Re: **Montgomery 206 Realty (Dunkin')**  
**Conditional Use + Amended Preliminary and Final Site Plan**  
Route 206 & Route 518  
Block 28005, Lot 64  
HC Highway Commercial District

Date: August 13, 2021

**MONTGOMERY 206 REALTY**  
**AMENDED PRELIMINARY AND FINAL SITE PLAN**

RE: Montgomery 206 Realty – Dunkin'  
**Amended Preliminary and Final Site Plan**  
**Application #BA-04-21**  
**Engineering Review**  
Block 28005, Lot 4  
1276 US Highway 206  
Township of Montgomery, Somerset County

APPROVED CIRCULATION  
ROUTES

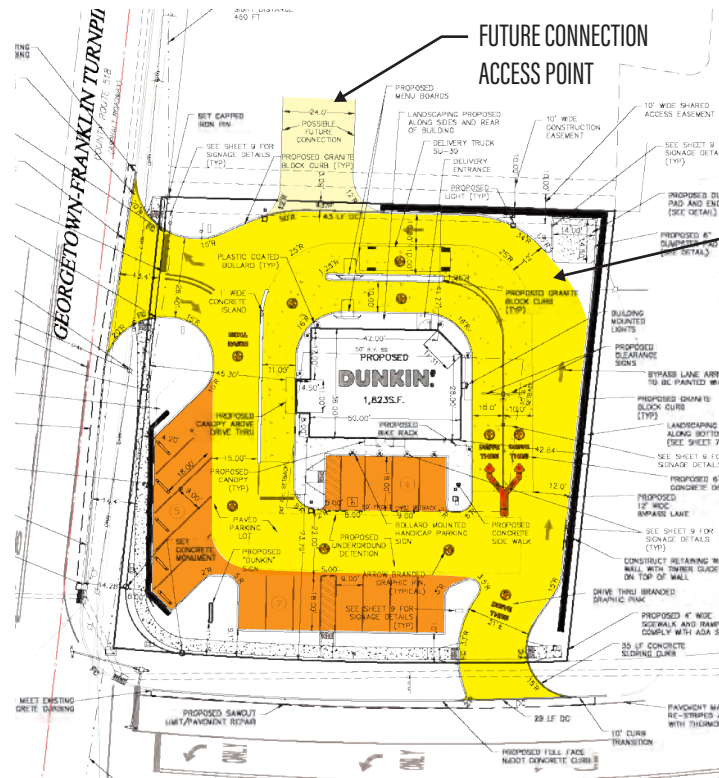
Based on NJDOT comments, the Route 206 driveway was amended from a “right-in/right-out” driveway to a “right-in only” driveway. This change has caused the internal circulation to be one-way only since the only means of egress from the site is a “right-out” onto Route 518. Having the only means of egress from the site as a “right-out only” only Route 518 could lead to potential illegal left-turns onto Route 518 from vehicles exiting the site.

2021 PROPOSED PLANTING PLAN

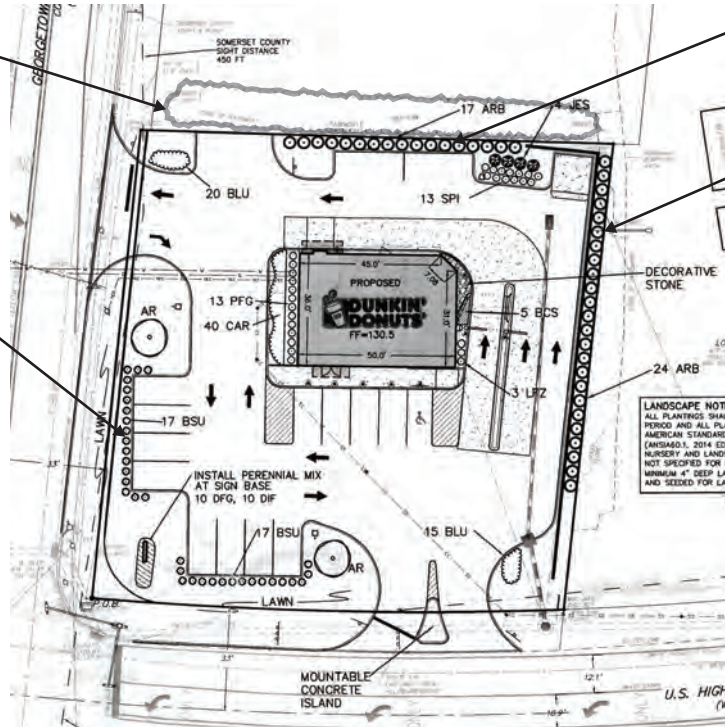
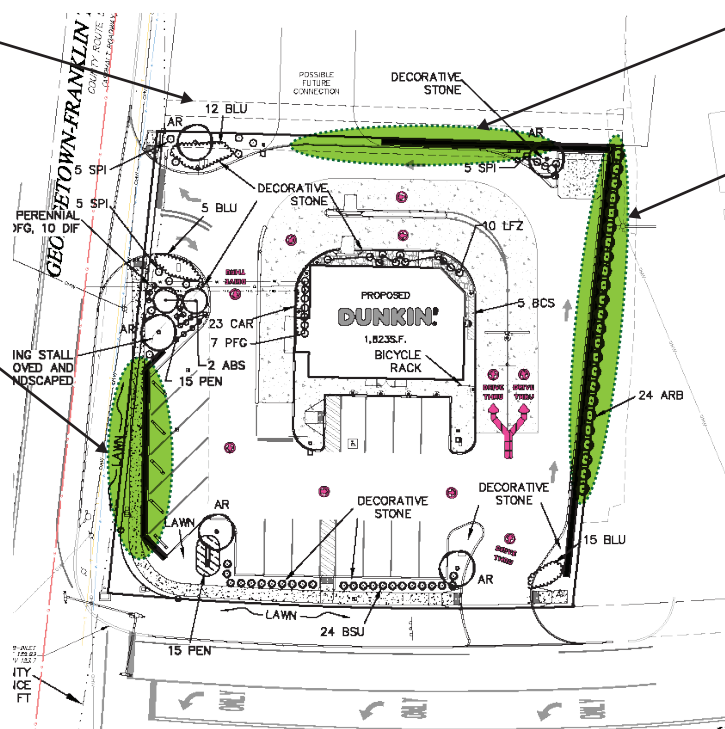
The screening along the north lot line (Tiger’s Tale) is the same as previously approved, but despite continuing to show buffer plantings along there, the planting bed has been reduced to approximately two (2) feet in width. The plants shown to be located there (arborvitae) requires a larger planting bed, as its mature width will be 5-6 feet in diameter or more. Therefore, this planting area would not appear to sustain the plantings shown and would not provide screening as required.

The applicant has removed the approved buffer planting along the western lot line and the southern lot line. Instead, the applicant is proposing to extend the retaining wall and add a future driveway connection along the western lot line leaving room for a small planting bed adjacent to the trash enclosure and the Route 518 driveway only. This leaves no screening between the drive-through lanes (now a double lane in this area) and the western property line.

BUFFER PLANTINGS  
REMOVED

INSUFFICIENT AREA  
FOR BUFFER PLANTING

BUFFER PLANTINGS  
REMOVED

The 2015 plans indicated existing vegetation to be retained on adjacent lot 59 (western property line). The current plans indicate that a construction easement will be located in this location, necessitating removal of this existing vegetation, further diminishing the degree to which drive-through elements will be visually screened.

The applicant has also added a retaining wall along the southern lot line; thus removing the approved buffer planting.

Some additional plantings adjacent to the ingress drive from Route 518 have been added, but these are not sufficient to satisfy this standard. *The Board should examine these changes and their impacts in order to consider whether relief should be granted from this standard.*
